**PROJECT NAME:: FACD08 RESTROOMS AT PREBLE TRUCK PARKING**  
**PROJECT No.: DOT-250005**

**ADDENDUM NUMBER ONE (1)**

February 27, 2026

SHEET  
**A.501**

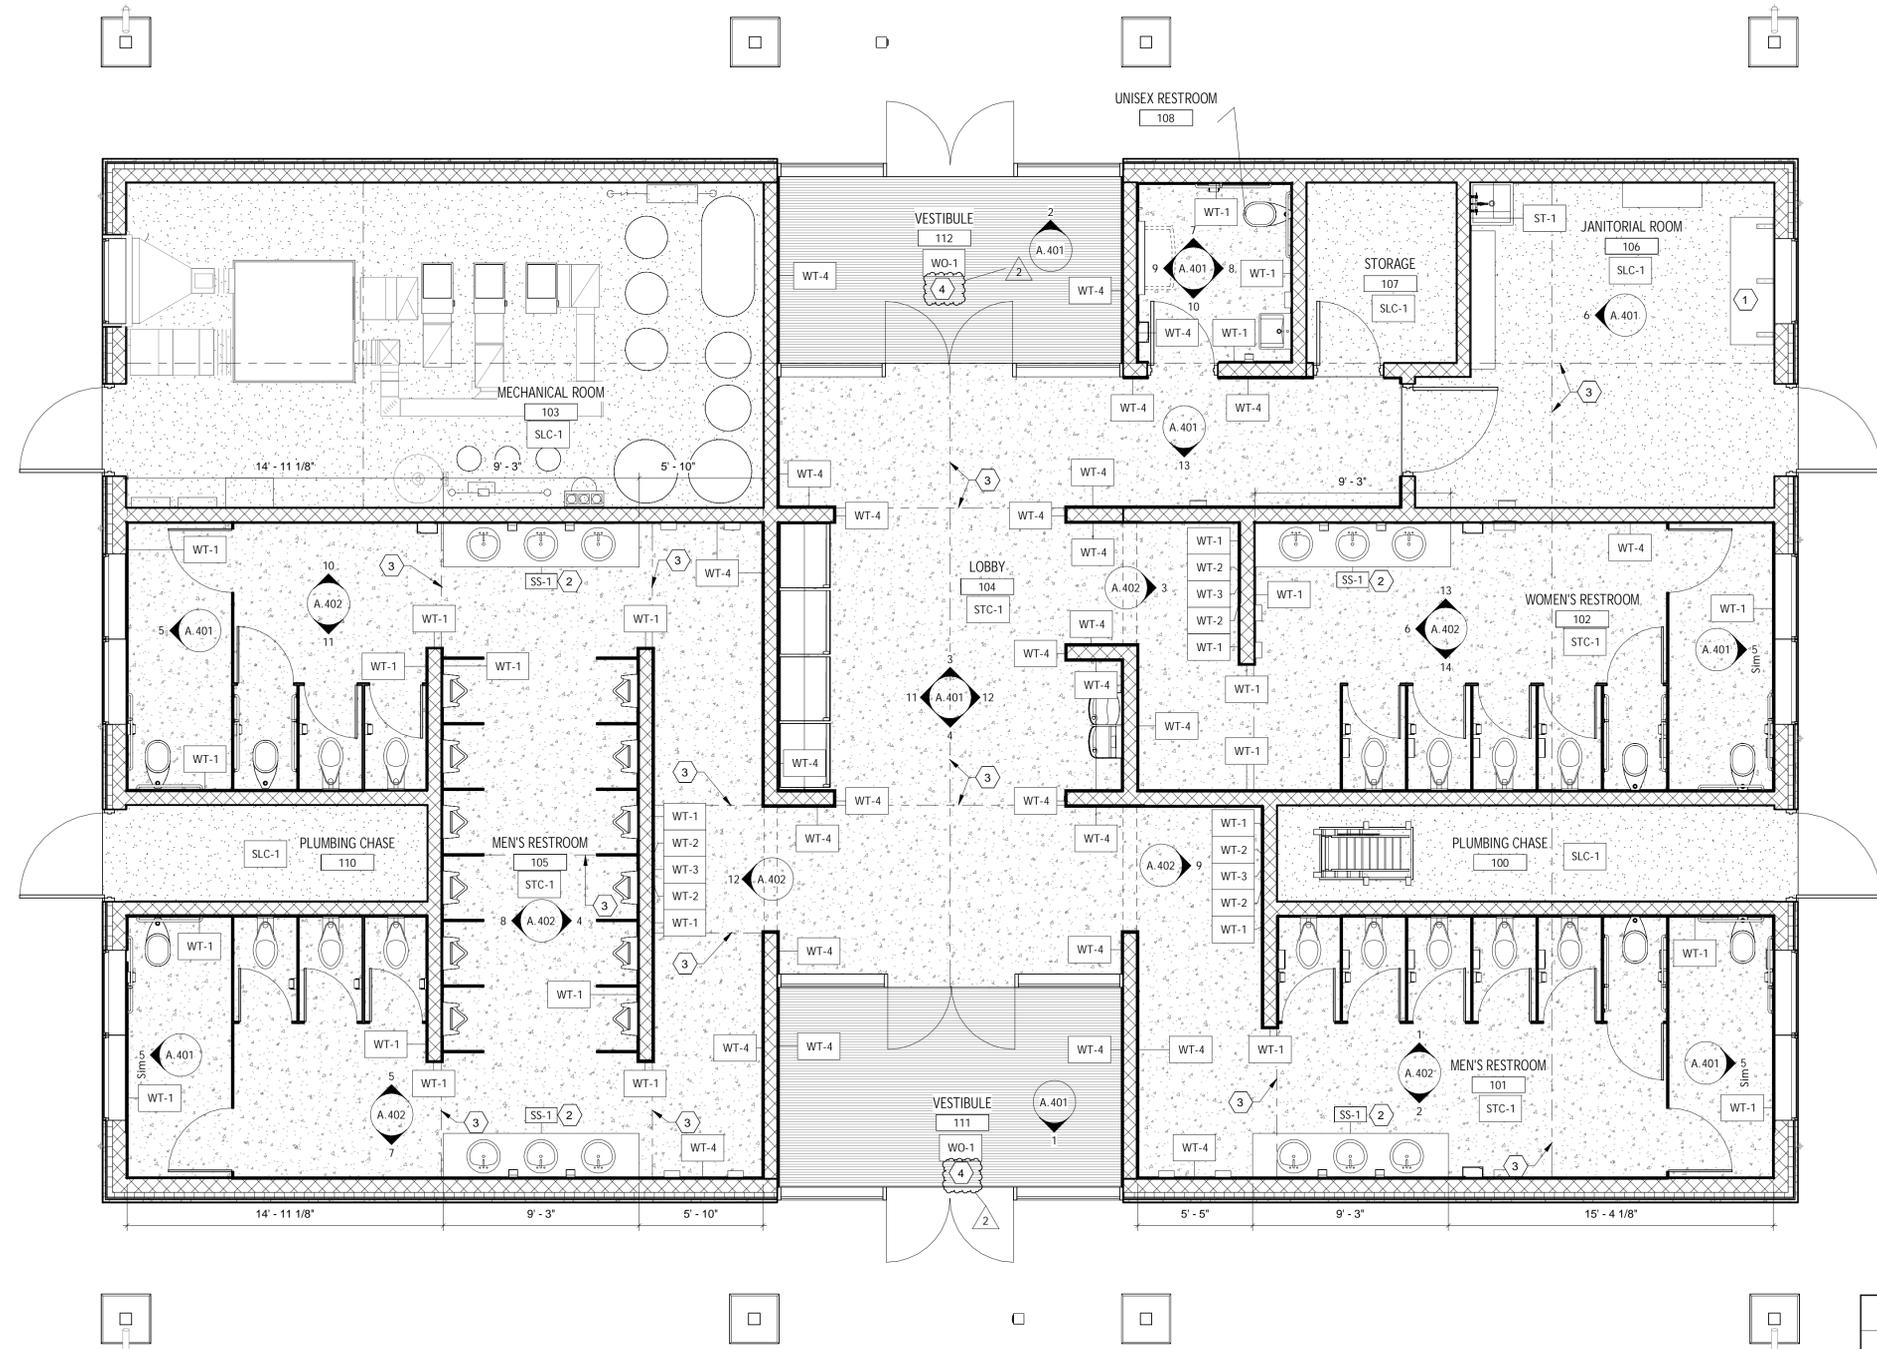
D-03. A.300, A.302, A.501, A.600, A.601 Verbiage and detailing were added for walk off mat installation.

- CODED NOTES:**
- 24"x6'-0" DESK COUNTER
  - 24"x9'-3" LAVATORY COUNTER
  - CONTROL JOINTS
  - DEPRESS SLAB 3/4" FOR WALK OFF MAT INSTALLATION

SHEET  
**A.601**

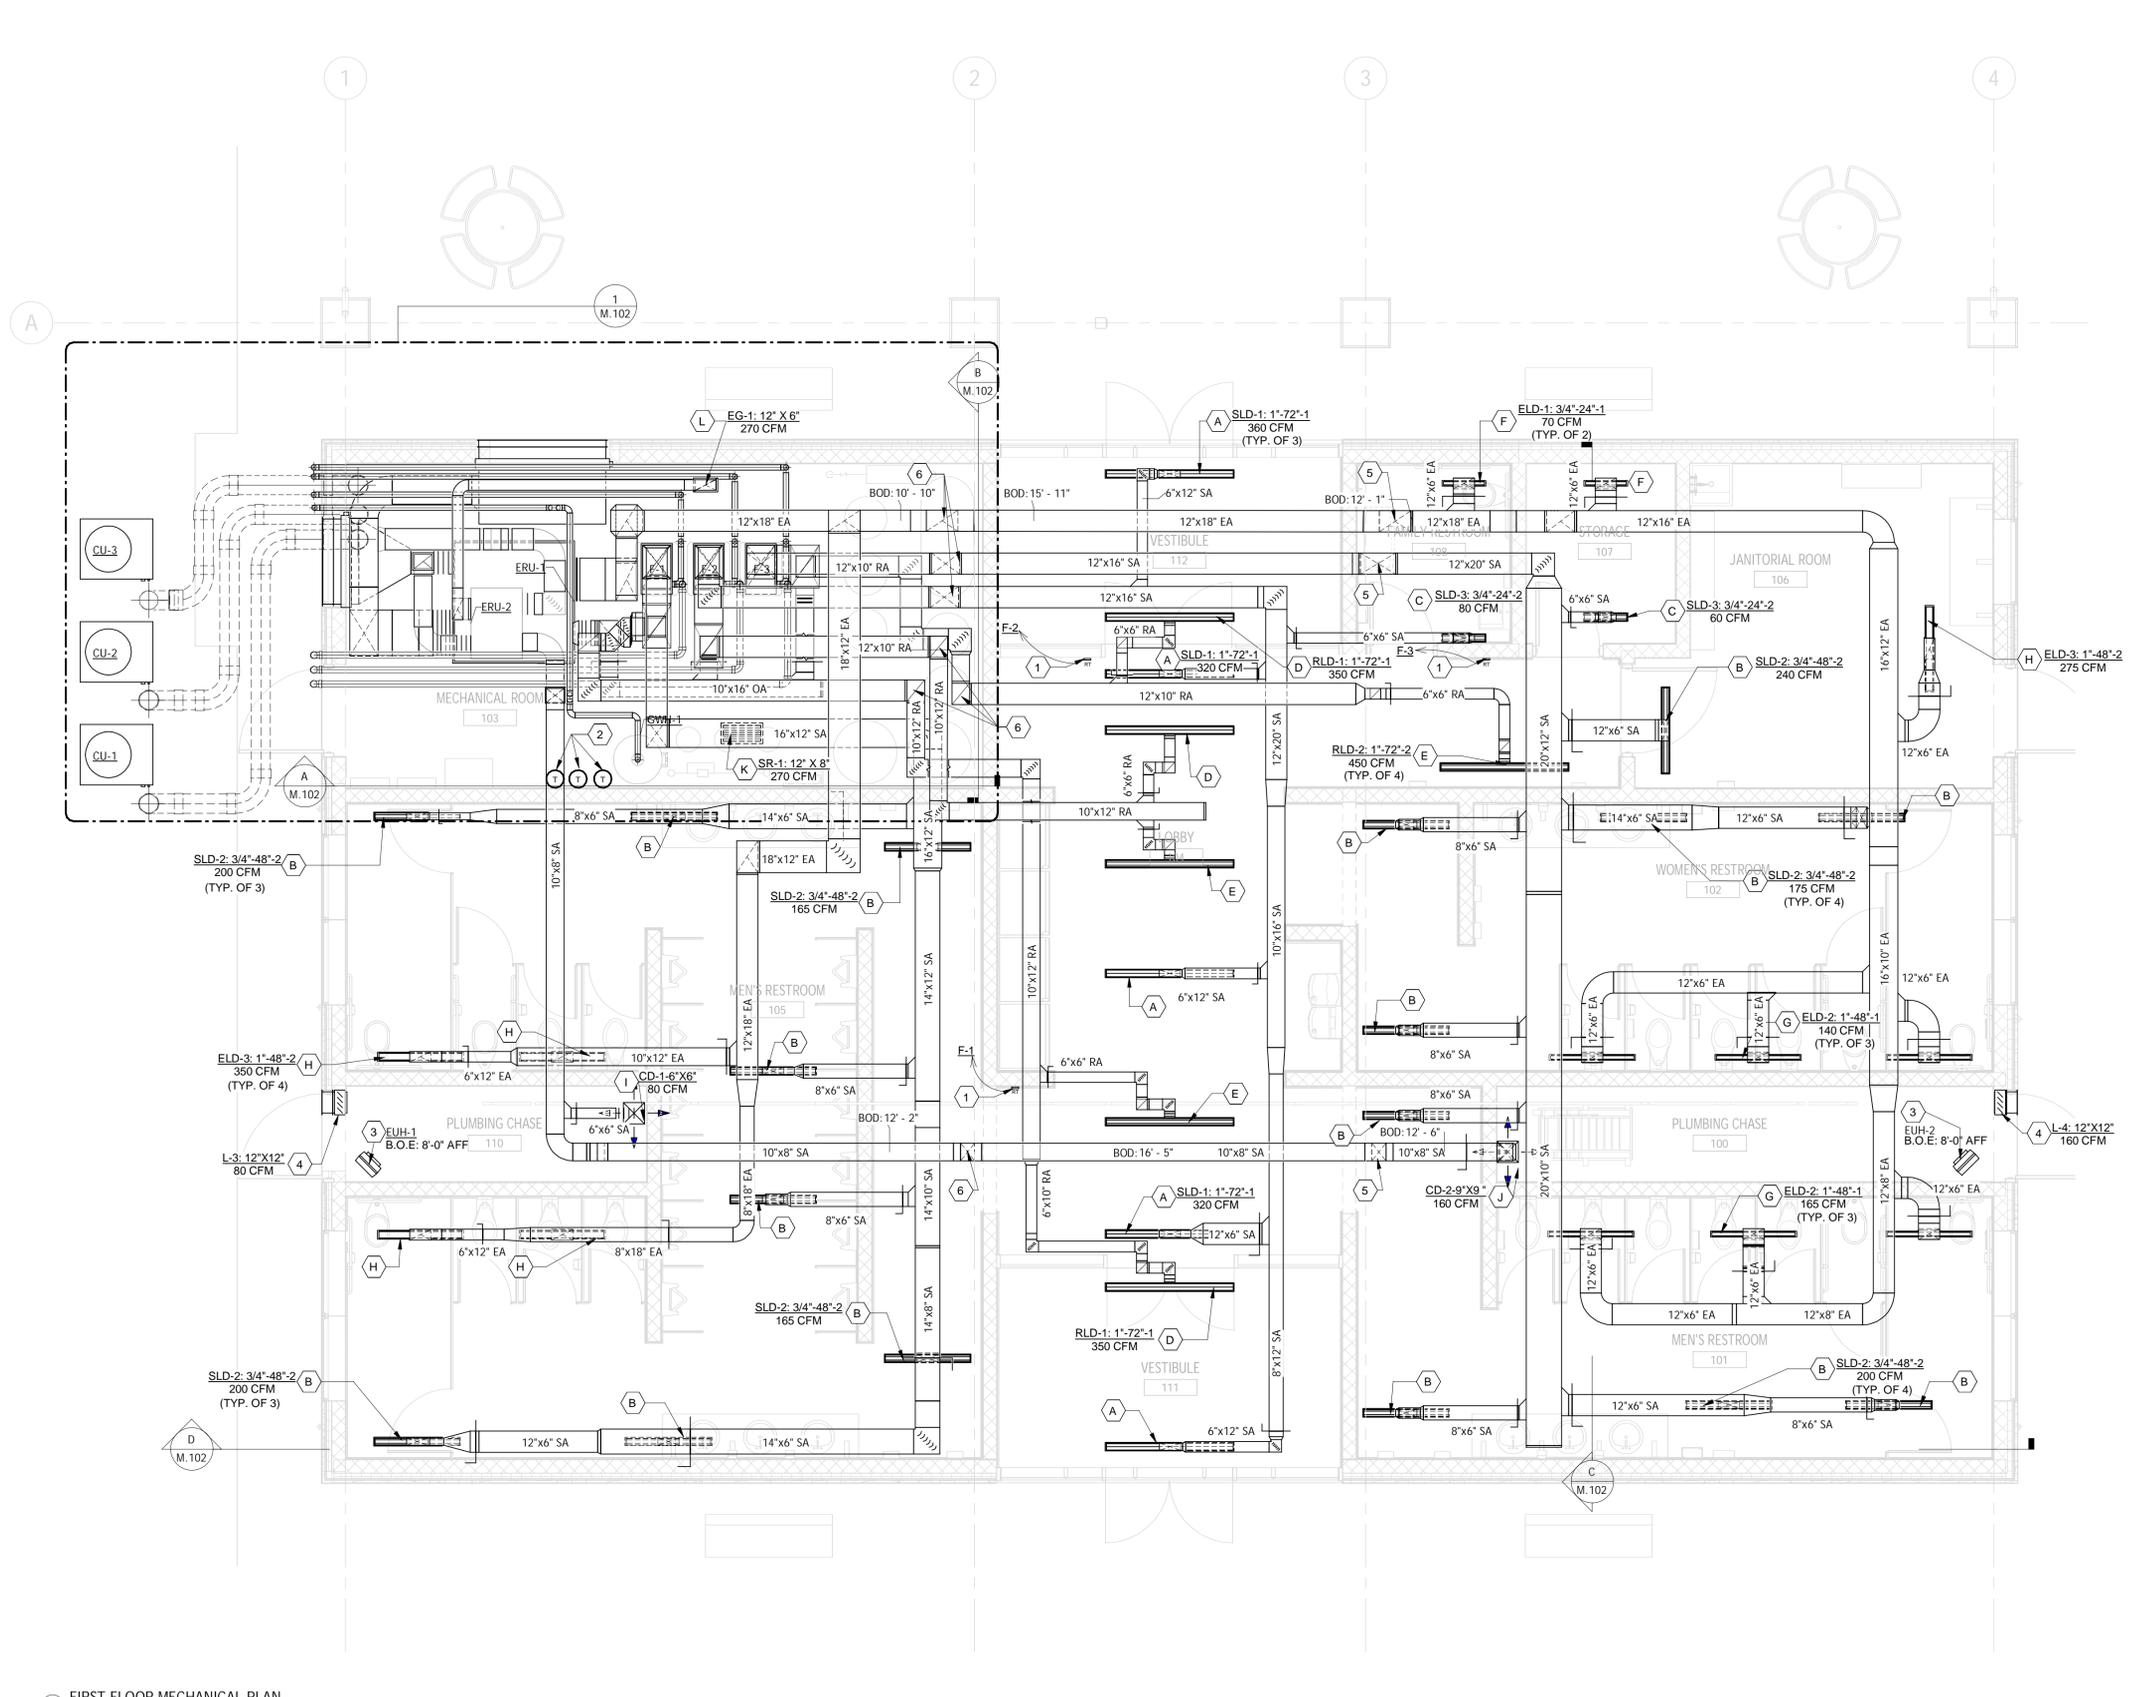
D-04. A.601 Wall tile WT-3 was revised to match WT-1

**RFI-7.** Please provide details for WT-3 custom water jet tiles?

- . **Response:** WT-3 is now just WT-1. The letters have been removed from the scope.

1 FIRST FLOOR MECHANICAL PLAN  
 1/4" = 1'-0"

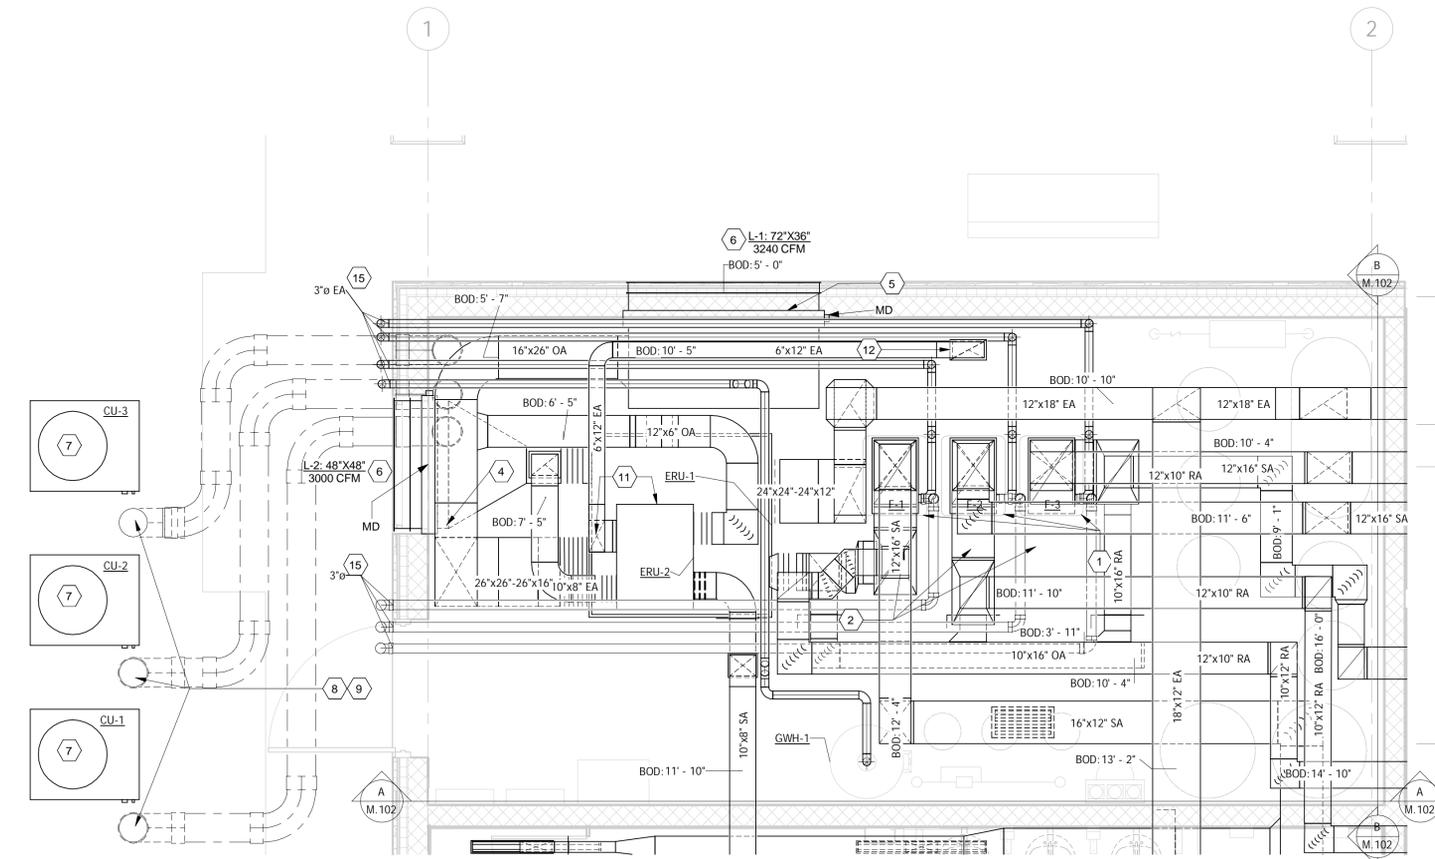
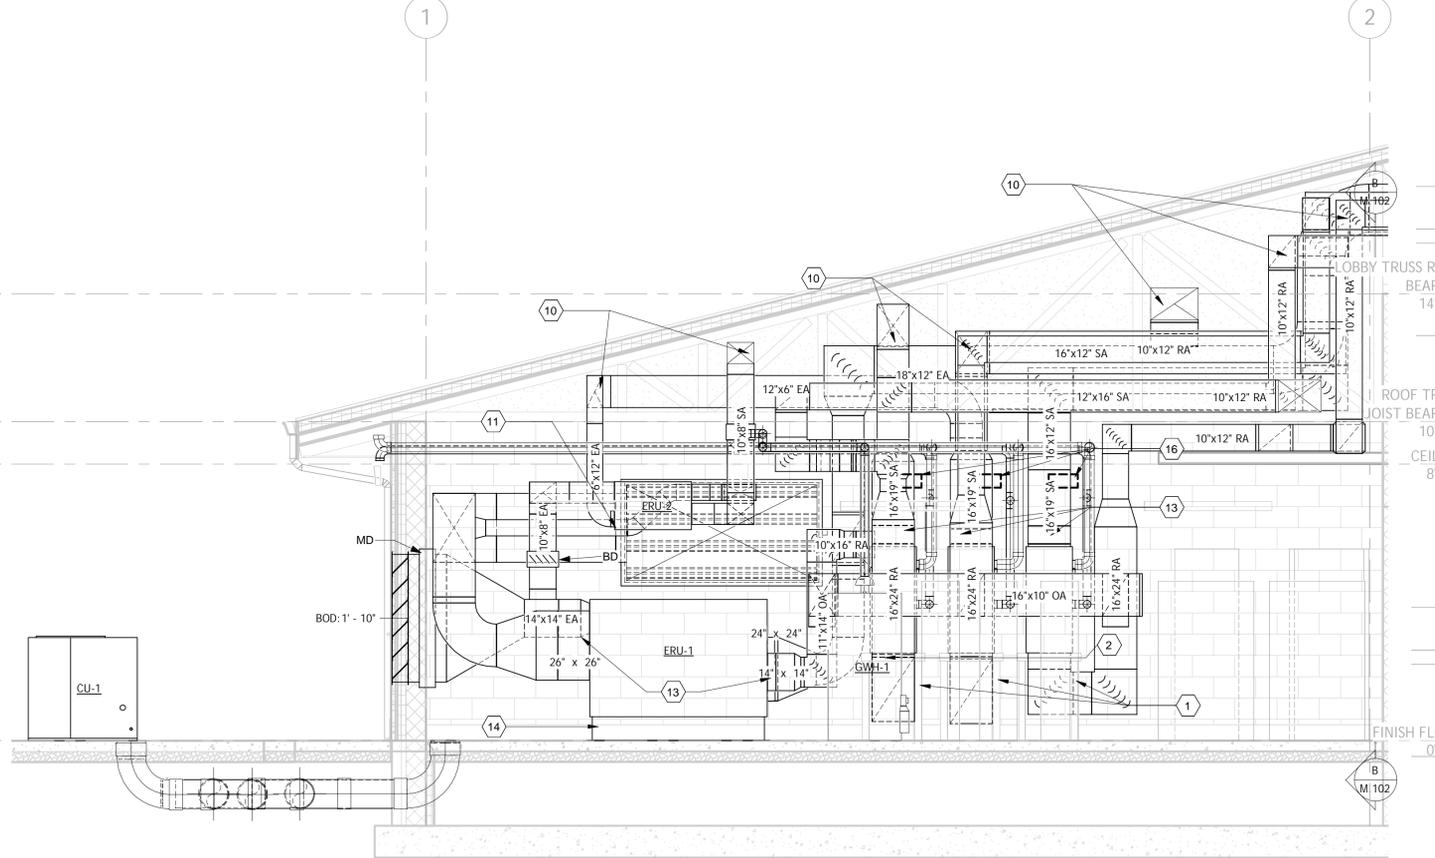
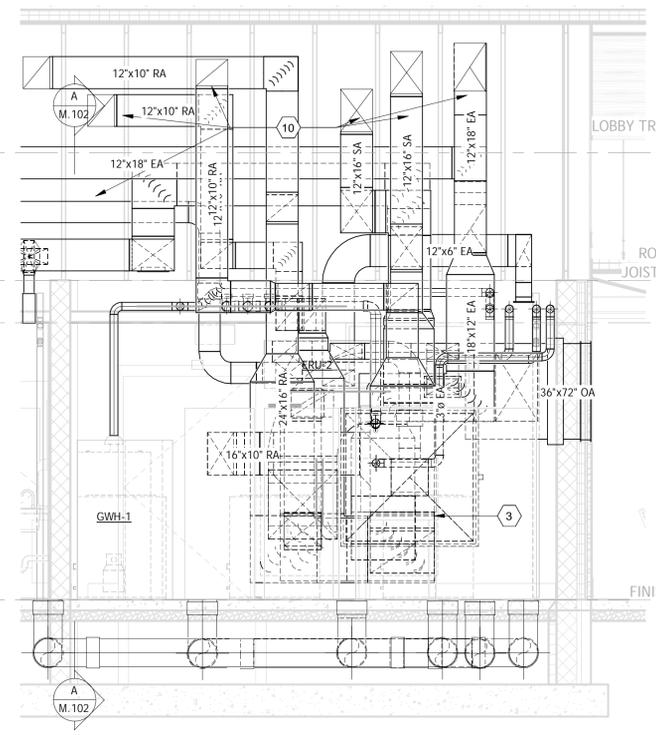
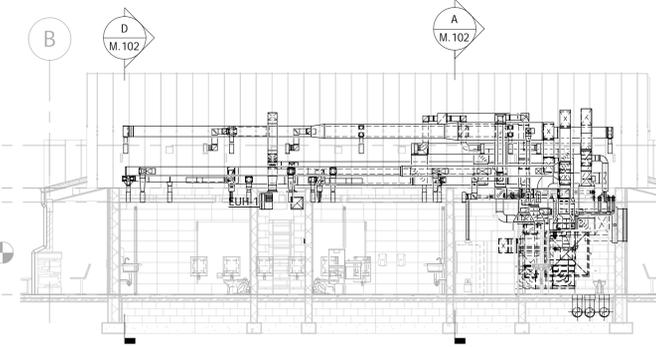
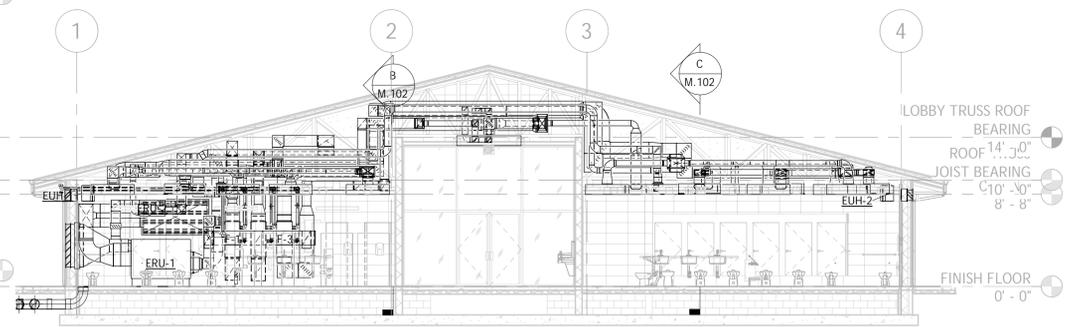
D-05. A.102, M.101 & M.102 Revised Mechanical Room ductwork to provide three independent supply, return, and outside air systems (via ERU-1 plenum) for new A2L refrigerant furnaces, per manufacturer requirements; linear diffusers replaced with supply registers and exhaust grilles, with coordination updates.

**11 AIRFLOW SCHEMATIC**  
N.T.S.

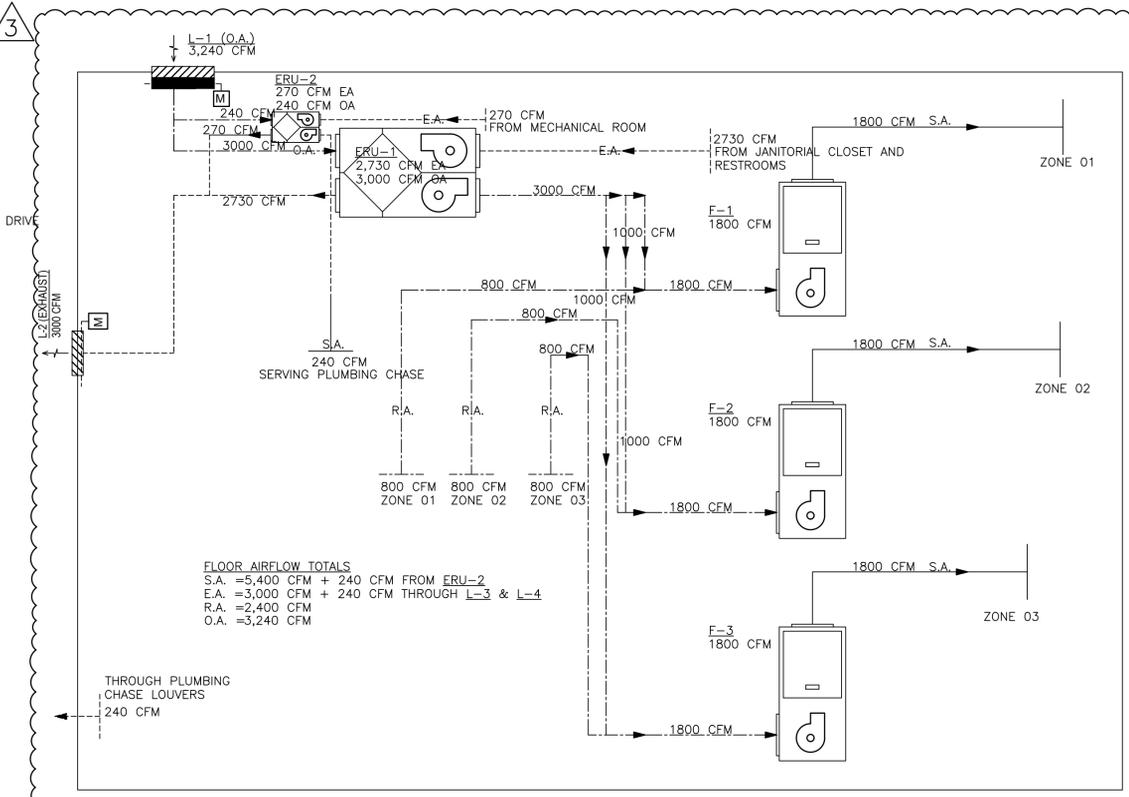
D-06. M.501 Revised airflow schematic
